UNITED STATES PATENT AND TRADEMARK OFFICE

APPLICATION NO.	FILING DATE	FIRST NAMED INVENTOR	ATTORNEY DOCKET NO.	CONFIRMATION NO.
10/561,422	12/19/2005	Kai Sorge	AG009	6390

FINAL REJECTION

Fig. 1

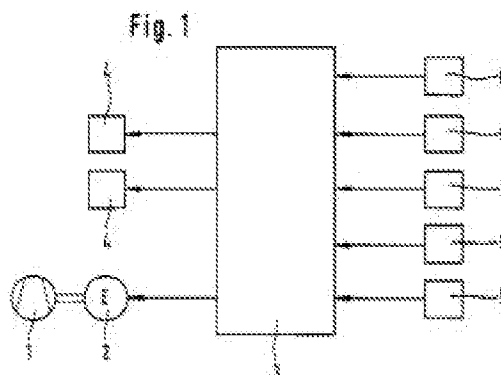
Regarding Independent **Claim 13**, and in reference to Figure 1 shown immediately

above, Kutscher et al. (Kutscher) discloses a compressor control system that cycles a compressor

unit on or off based on the relationship existing between a compressor temperature and threshold

values. The threshold values are utilized in a mathematical physical model stored in memory of

a control unit for carrying out thermal modeling analysis via characterization of heating/cooling

properties of the compressor. Specifically, Kutscher's control system utilizes thermodynamic

properties and relationships existing between the compressor and the surrounding air in order to

calculate the on-time (or off-time) of the compressor, and ultimately, arrive at a desired

compressor temperature (See Column 2, Lines 13-32) Essentially, Kutscher's control system is

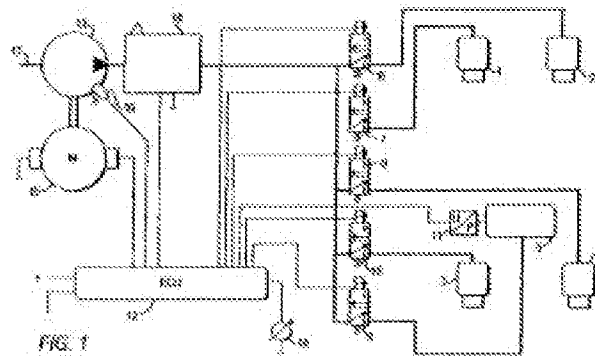
In regards to dependent **Claim 15**, and in reference to Figure 1 shown

immediately above, the Meier portion of the combination specifically discloses

using the backpressure in the compressor system in order to accurately calculate

compressor temperature. In particular, Meier discloses "A method and apparatus

for controlling a compressor suitable for delivery of pressurized fluid to a

pressurized fluid system, wherein the delivery of the pressurized fluid to the

pressurized fluid system can be cycled on and off as a function of a temperature

signal received from a temperature sensor. The delivery of pressurized fluid is

turned off when the temperature signal exceeds a temperature limit value that is

based on the backpressure caused by the pressurized fluid system." (Abstract)
